ST. TAMMANY PARISH

Addendum No.: 3

Bid#: 21-26-2

Project Name: Slidell Library Parking Lot

DRAINAGE & GRADING PLAN
SLIDELL LIBRARY (ROBERT BLVD)
NEW PARKING LOT
ST. TAMMANY PARISH GOVERNMENT, OWNER

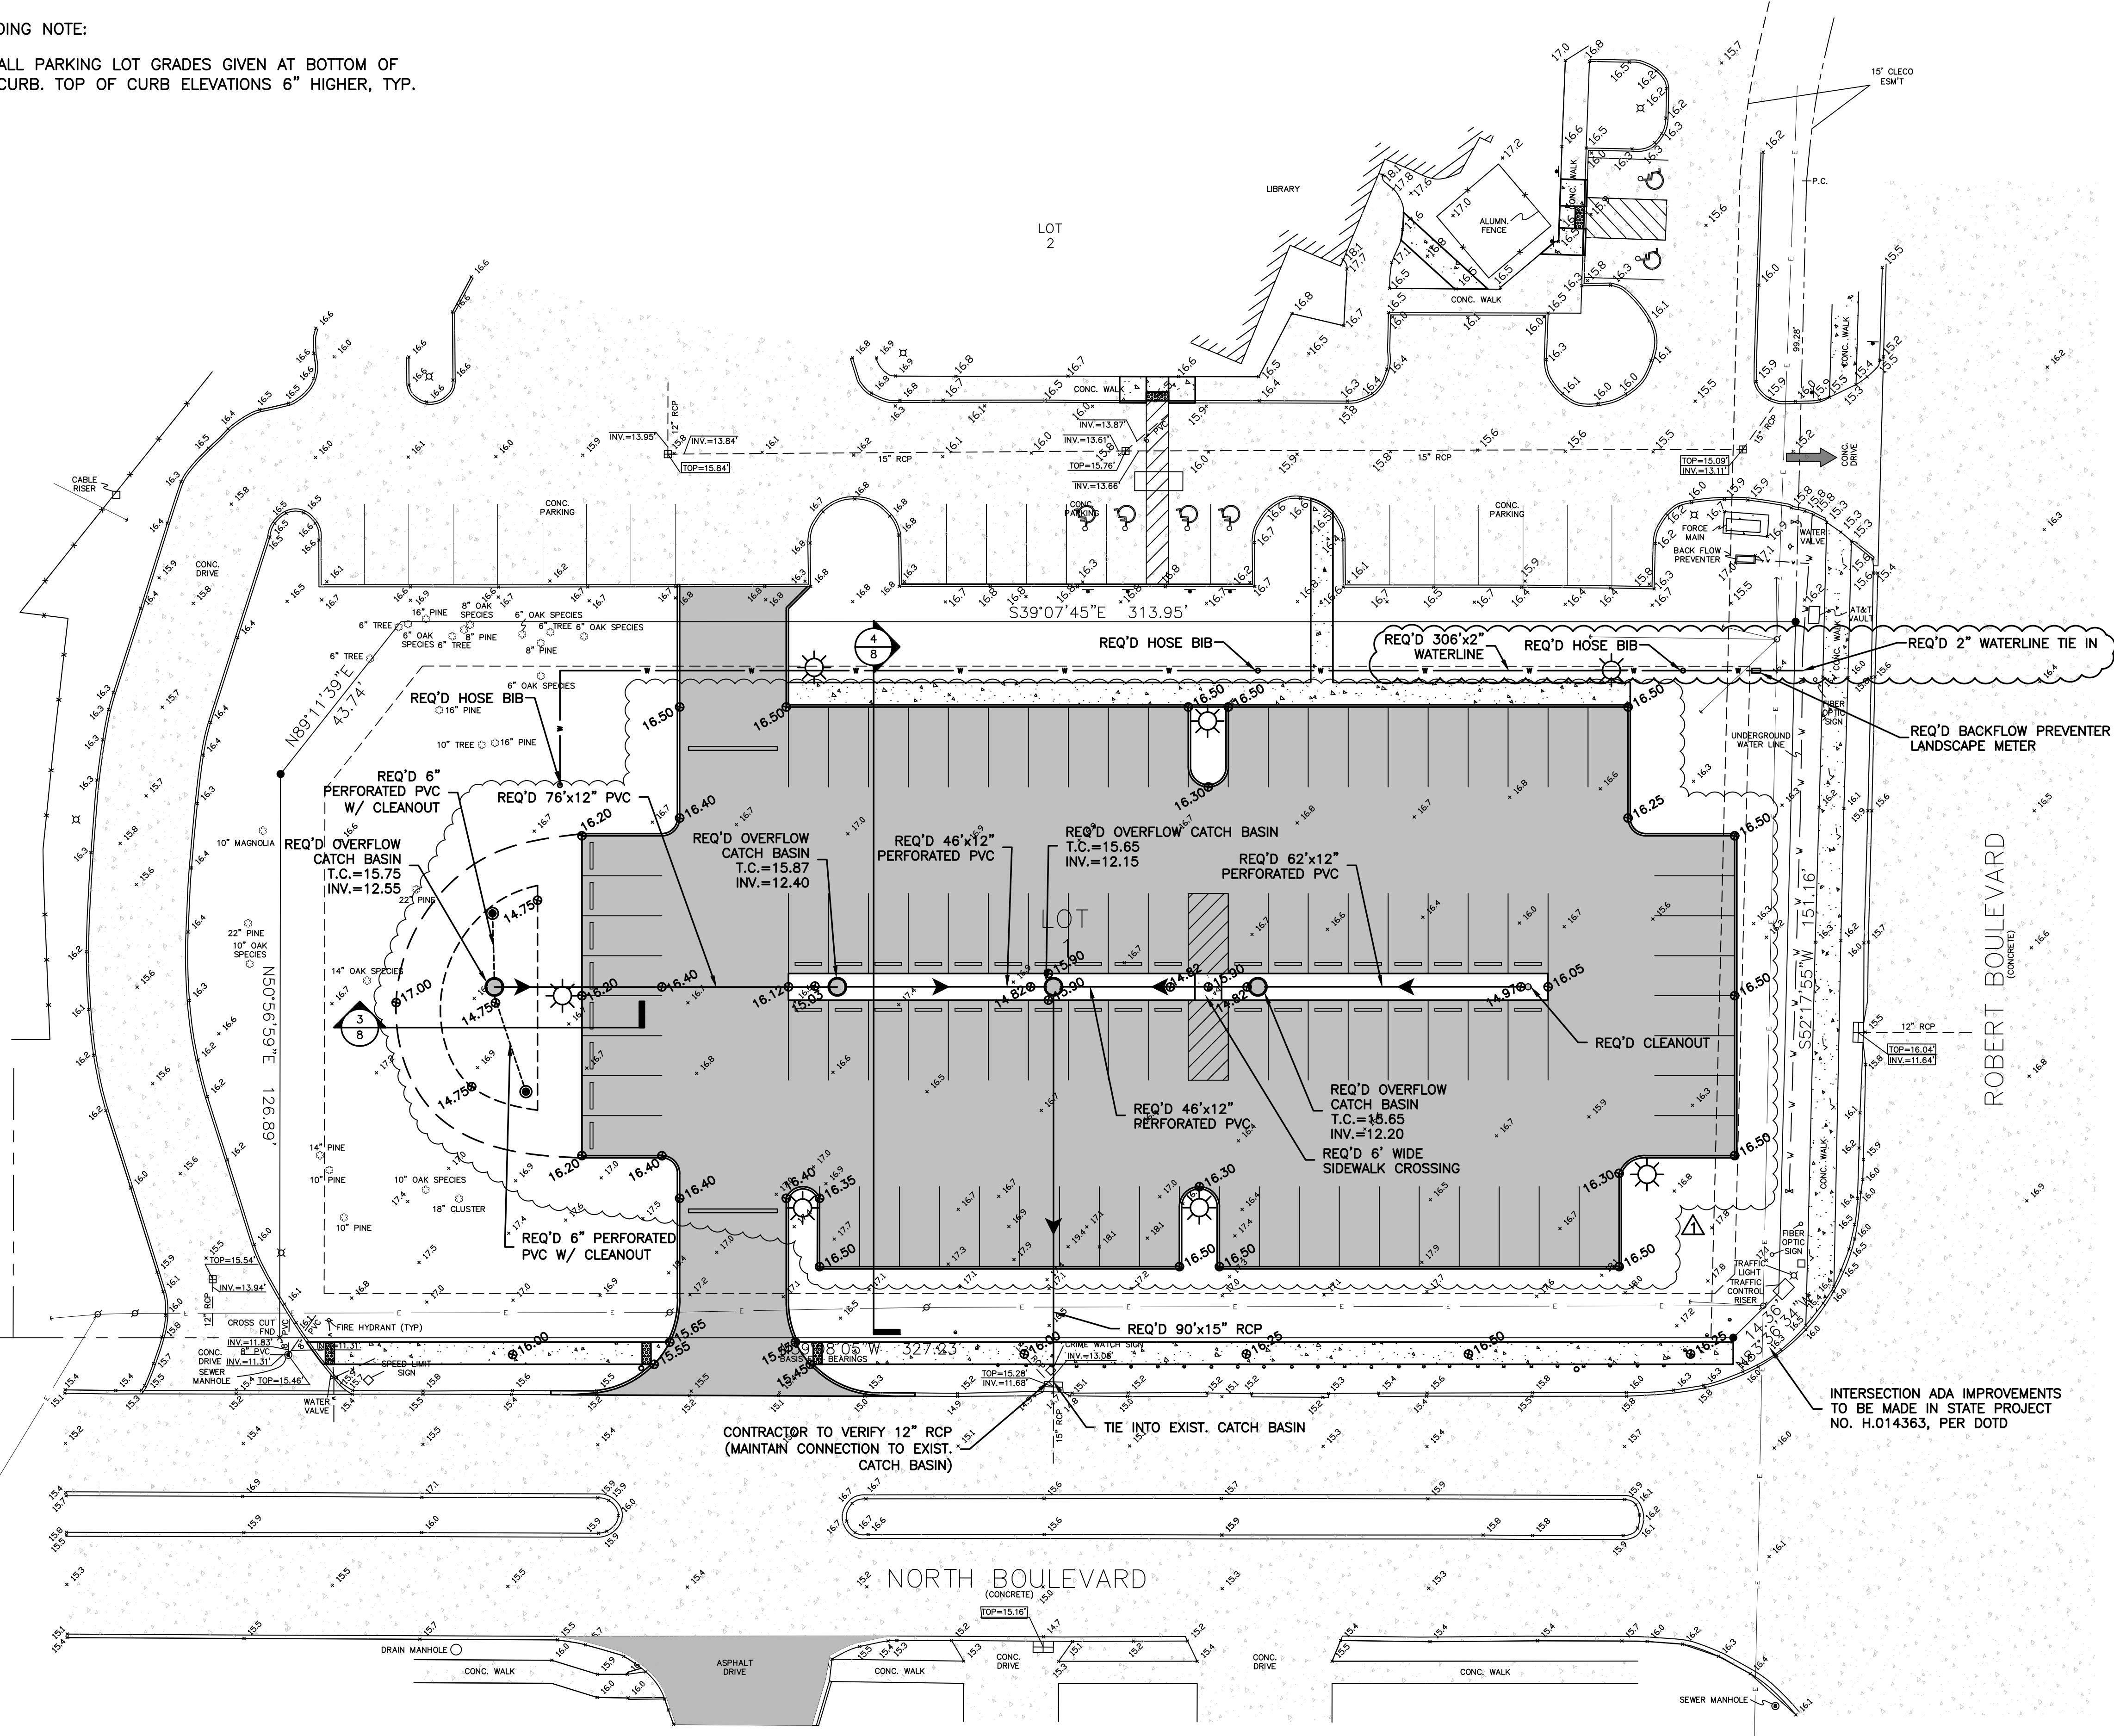
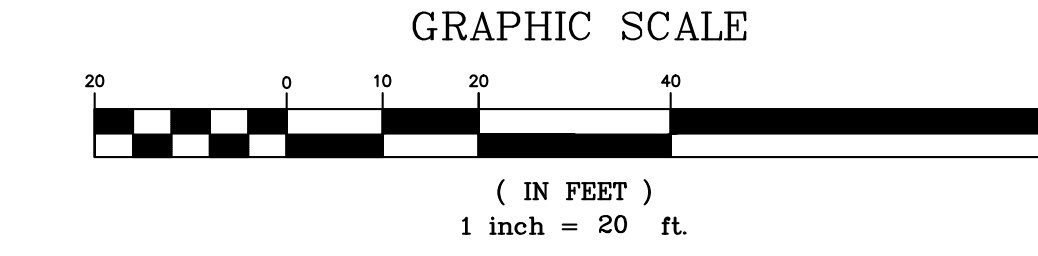
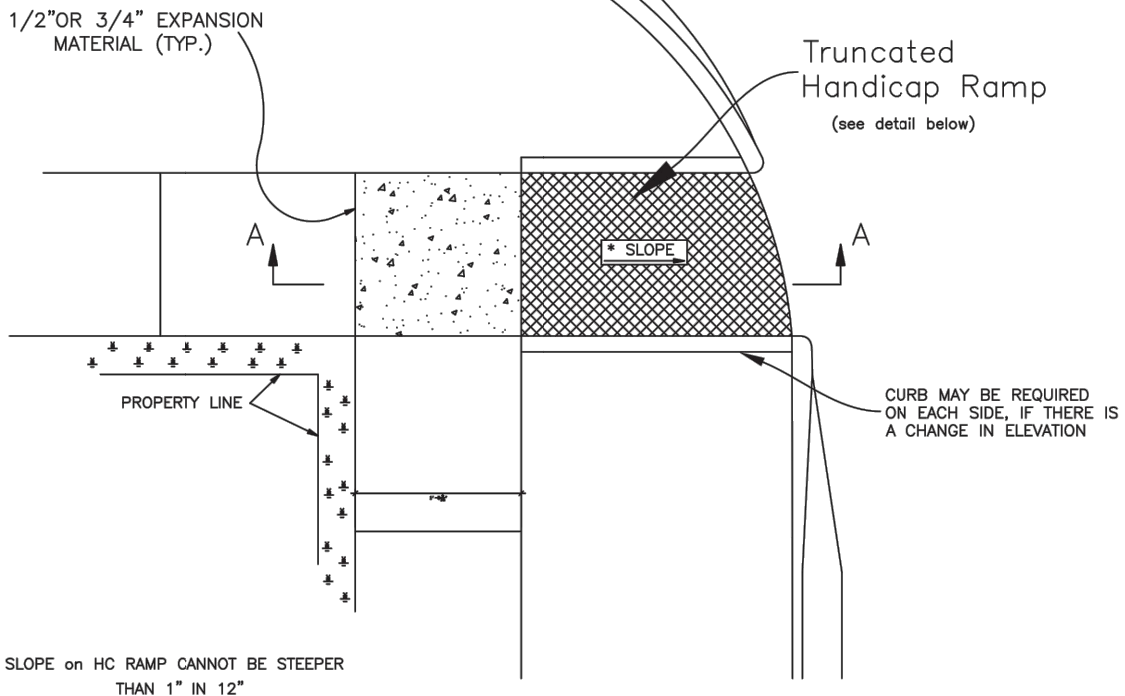
AD3.8 Drawings, Sheet No. 6, Drainage & Grading Plan. Delete this sheet in its entirety and replace with Sheet No. 6, Drainage & Grading Plan numbered AD3-7.

- 10/01/2021 PARKING LOT LOWERED 9" PER SLIDELL PERMITTING REQUIREMENTS.
- 10/01/2021 WATER LINE TIE IN MOVED FROM SERVICE LINE TO MAIN LINE.

SK-01
Sheet no.
of sheets

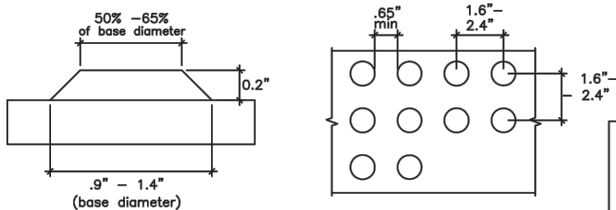
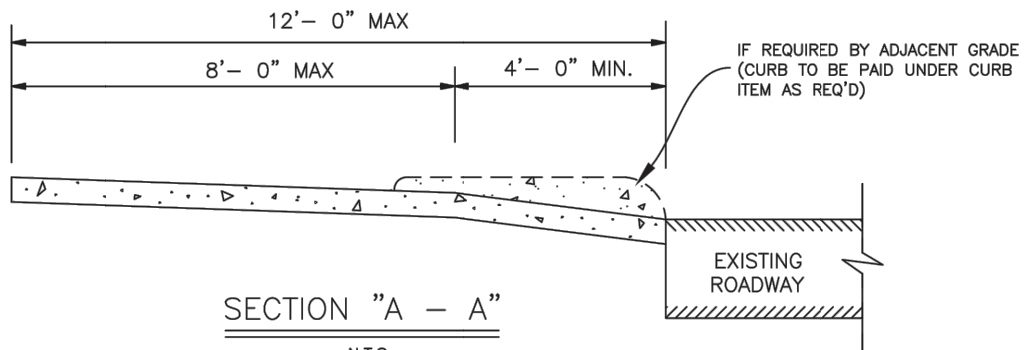
AD3.9 Drawings, Sheet No. 7, Miscellaneous Details. Add Sketch SK-01 & SK-02, Slidell Standard Sidewalk Details numbered AD3-8 thru AD3-9.

MISCELLANEOUS DETAILS
SLIDELL LIBRARY (ROBERT BLVD)
NEW PARKING LOT
ST. TAMMANY PARISH GOVERNMENT, OWNER

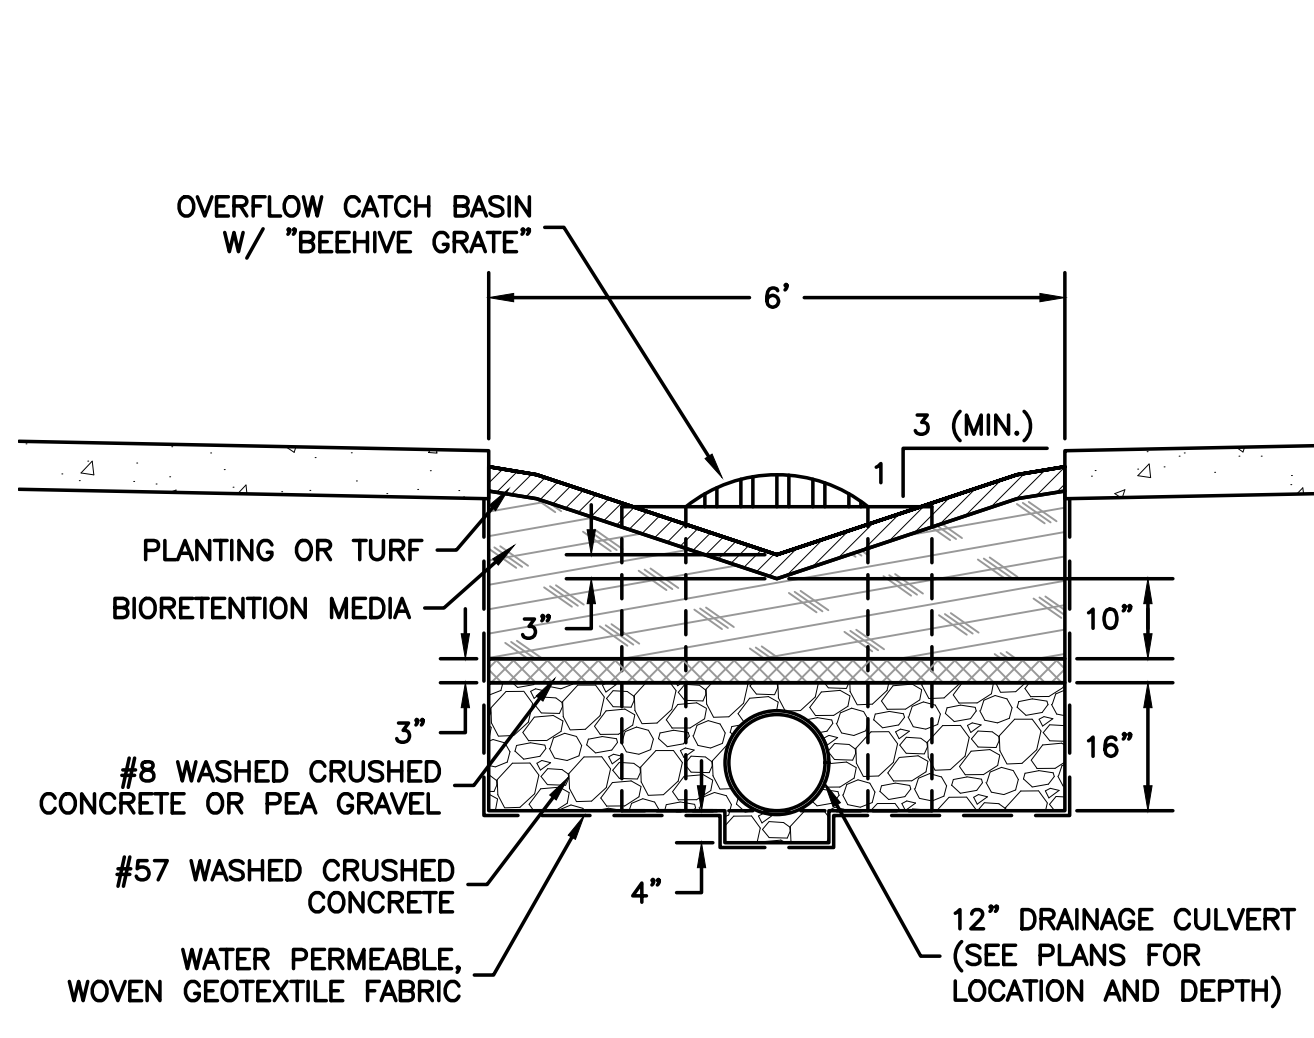
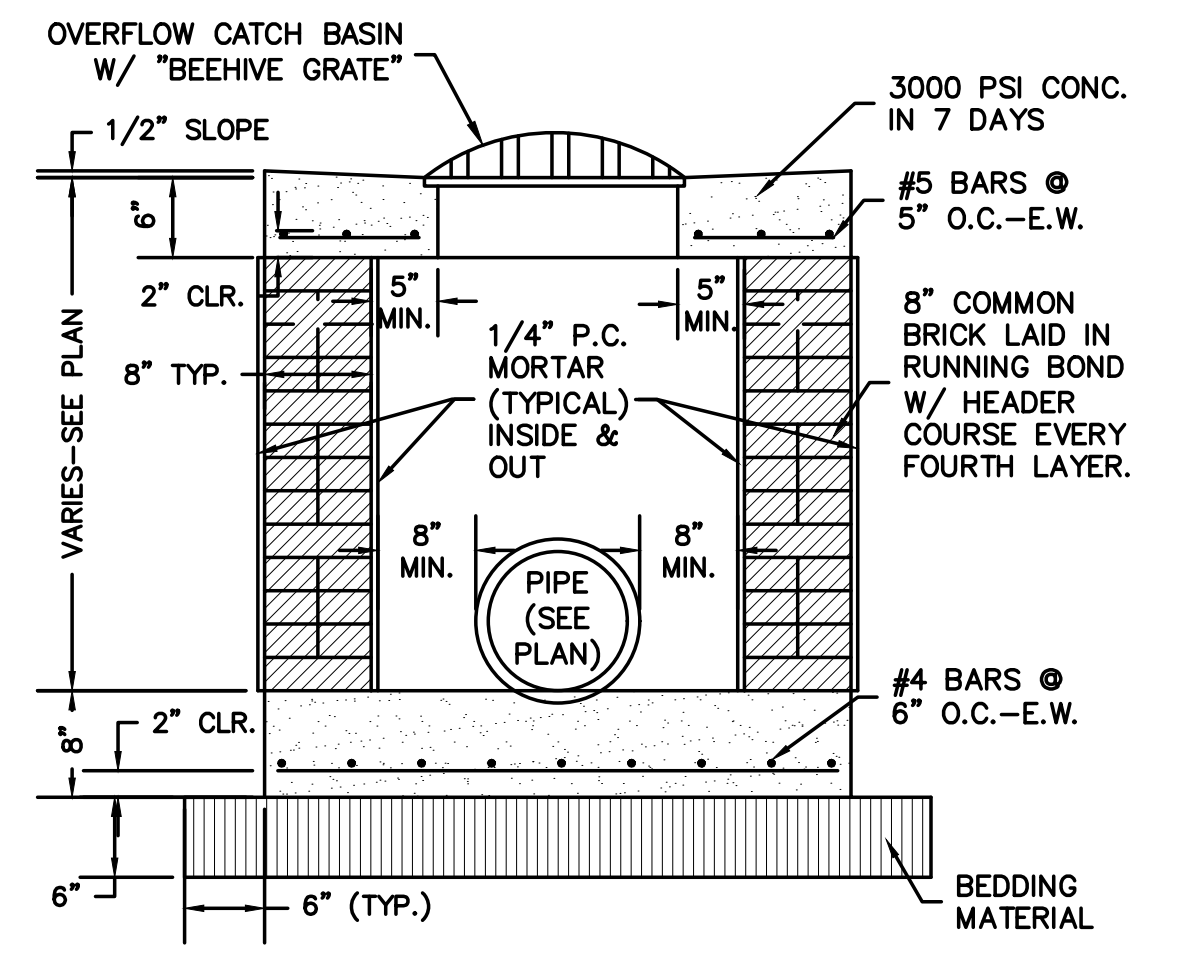
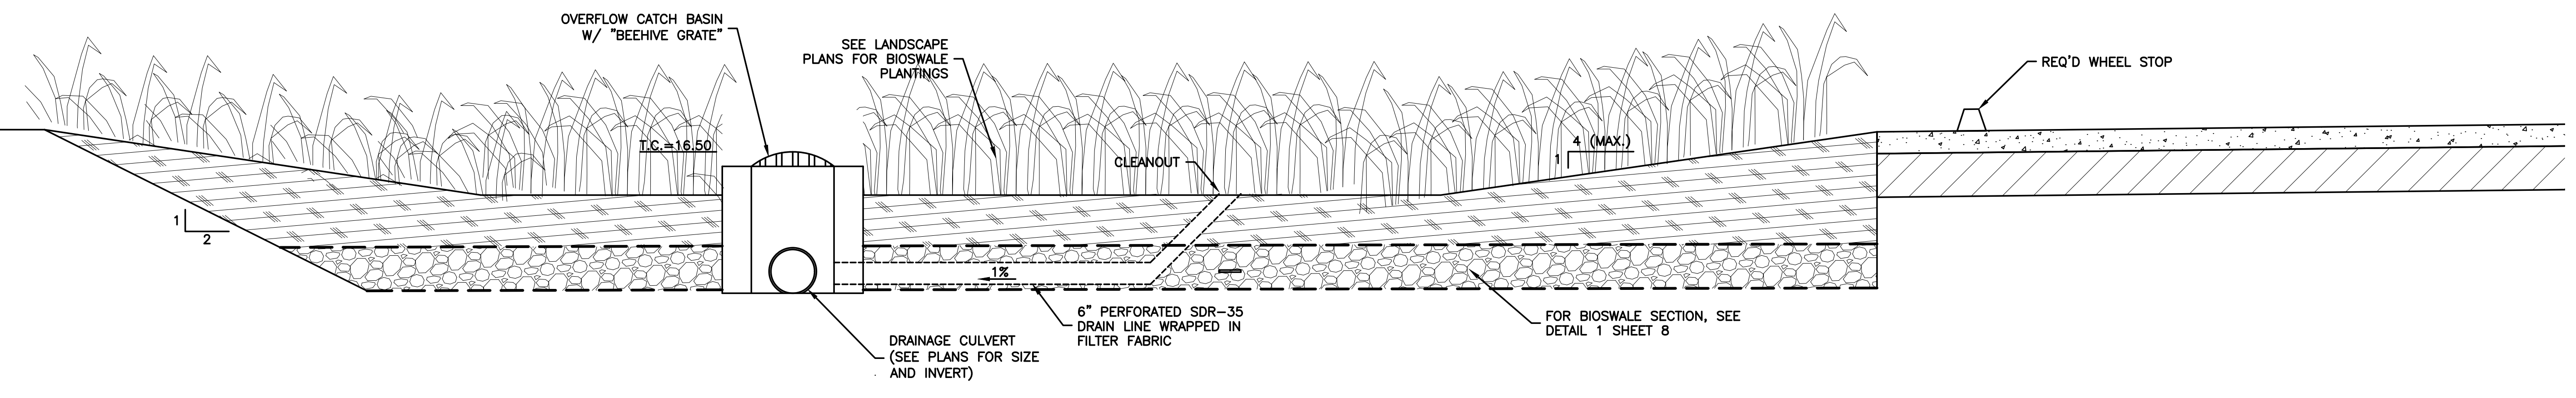
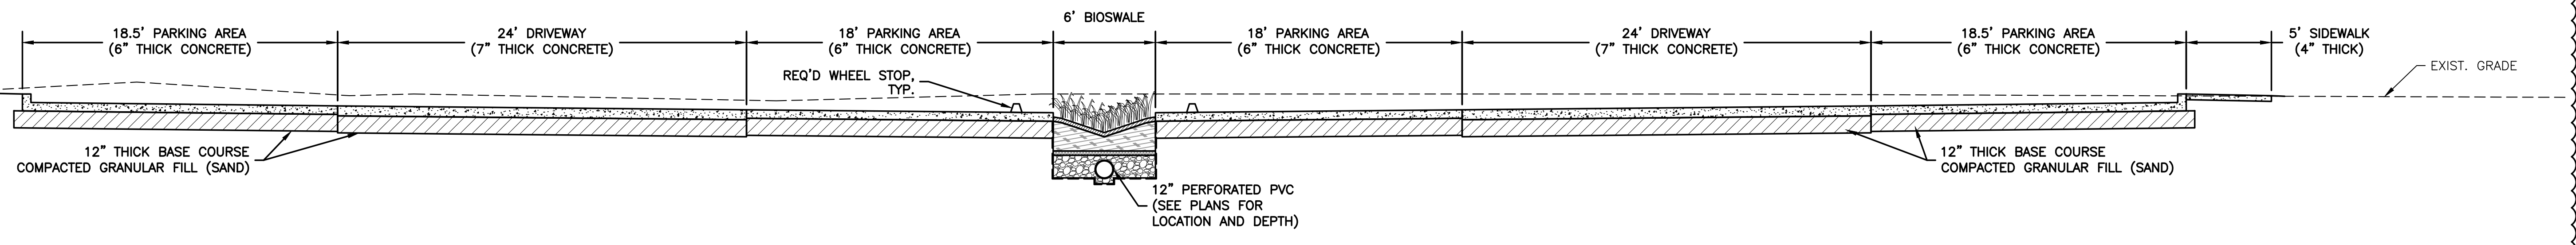
AD3.10 Drawings, Sheet No. 8, Miscellaneous Details: Delete this sheet in its entirety and replace with Sheet No. 8, Miscellaneous Details numbered AD3-10.

10/01/2021 PARKING LOT LOWERED 9" PER SLIDELL PERMITTING REQUIREMENTS.
